**Pathfinder Mines Corporation**

**SOURCE MATERIAL LICENSE**

**AMENMDMENT APPLICATION**

**SHIRLEY BASIN URANIUM FACILITY**

FIGURE 5-1  
ORGANIZATIONAL  
CHART

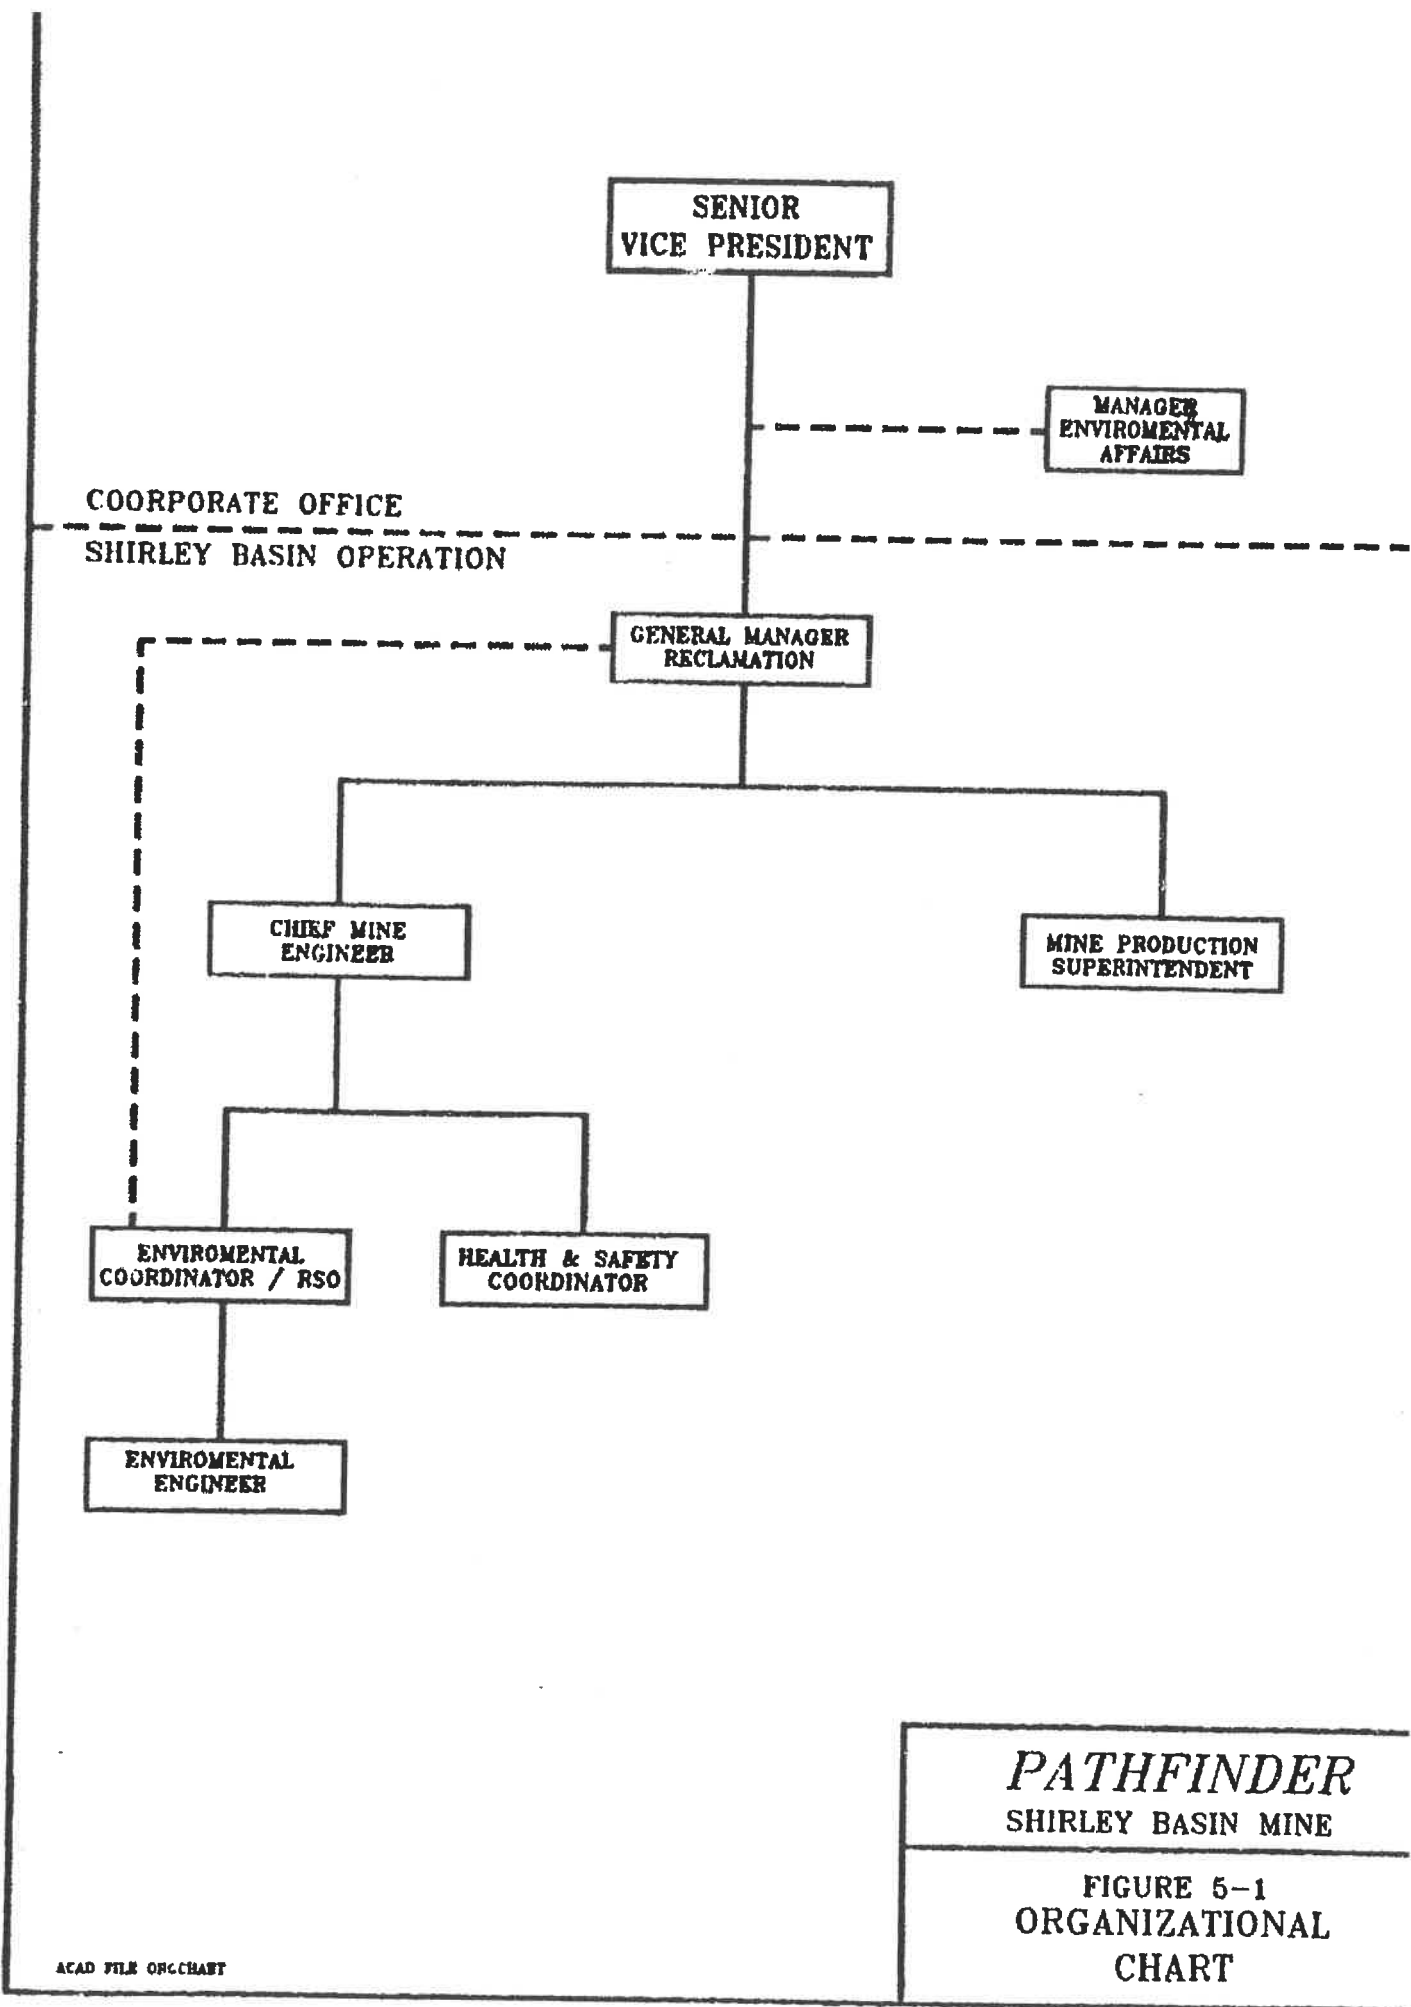
(Rationale: Mill Decommissioning)
